Amendments to the Drawings:

REMARKS/ARGUMENTS

Appl. No. 09/825,903 Amdt. Dated January 13, 2005 Reply to Office action of September 28, 2004 Annotated Sheet Showing Changes Sheet 2 of 2

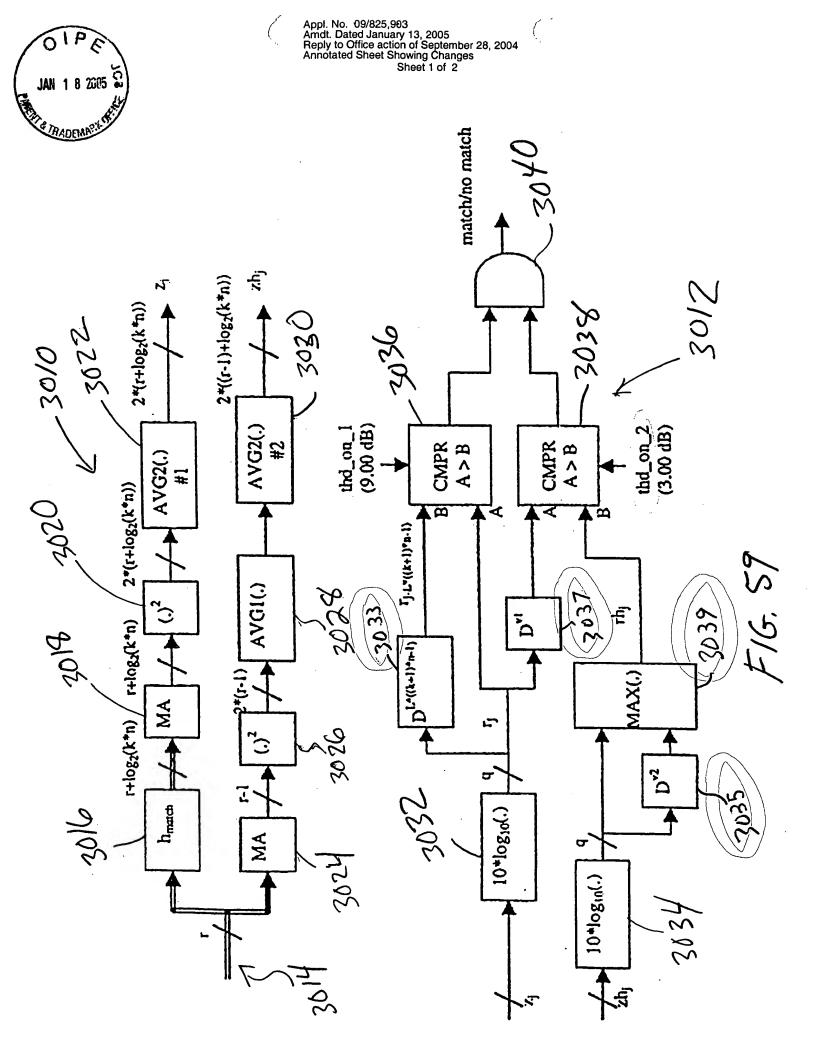
The Examiner has objected to the Drawings under 37 C.F.R. § 1.83(a) as failing to show every feature specified in the claims. In particular, the Examiner has objected to the steps of "delaying," "multiplying," and "comparing" in lines 14 - 21 of Claim 1, as well as in lines 23 - 34 of Claim 9, and the further steps of "multiplying," and "comparing" in lines 26 - 31 of Claim 1, as well as in lines 39 - 48 of Claim 9, as not being shown in the Drawings. The Examiner has furthermore objected to the "plurality of log operands" featured in Claims 8 and 9 as not being shown in the figures.

Regarding the step of "delaying," Fig. 59 shows three delay functions 3040, 3042, 3044 (3033, 3035, 3037 after amendment), also described on page 92 in lines 5 - 15 of the specification. The step of "delaying" claimed in Claim 1, lines 14 - 15, is reflected in delay function 3040 (3033 after amendment). Claim 9 has been cancelled.

Regarding the steps of "comparing," Fig. 59 shows two compare functions 3036, 3038, also described on page 91, line 32 through page 92, line 19. The step of "comparing" in Claim 1,

lines 19 - 21, is reflected in compare function 3036. The step of "comparing" in Claim 1, lines 29 - 31, is reflected in compare function 3038. Claim 9 has been cancelled.

The attached sheets of drawings in the appendix hereto include changes to Fig. 59 and Fig. 80. These sheets, which include Fig. 59 and Fig. 80, replace the original sheets including Fig. 59 and Fig. 80.
